World Forum for Harmonization of Vehicle Regulations

UN Regulation No. 48 (Installation of lighting and light-signalling devices):

Proposal for a new 08 series of amendments to UN Regulation No. 48

Submitted by the expert from the Special Interest Group*

Arrangements of approval marks

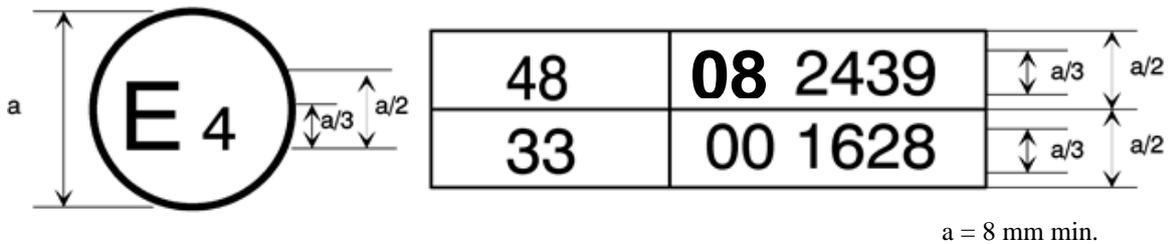
Annex 2, amend to read:

The above approval mark affixed to a vehicle shows that the vehicle type concerned has, with regard to the installation of lighting and light-signalling devices, been approved in the Netherlands (E4) pursuant to UN Regulation No. 48 as amended by the **08** series of amendments. The approval number indicates that the approval was granted in accordance with the requirements of UN Regulation No. 48 as amended by the **08** series of amendments.

24. Editorial changes were introduced to update the number of the series of amendments in the marking examples.
